WSD Technical Service Bulletin #12-002

“65600C” to “65600B” Inventory Transfer Request

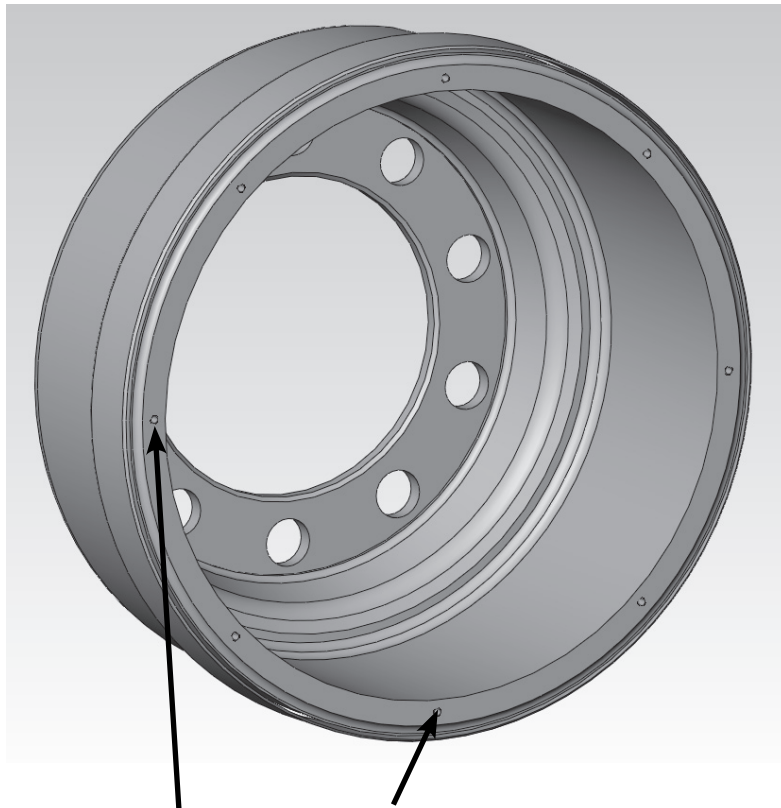
Webb Part # 65600C has 8 ea- 1/4-20 tapped holes that were designed for certain applications that require a Speedometer Pickup.

Webb Part #65600B is IDENTICAL to Part #65600C with the exception of these holes. 65600C can be used in its place with NO Fit, Form or Function Issues
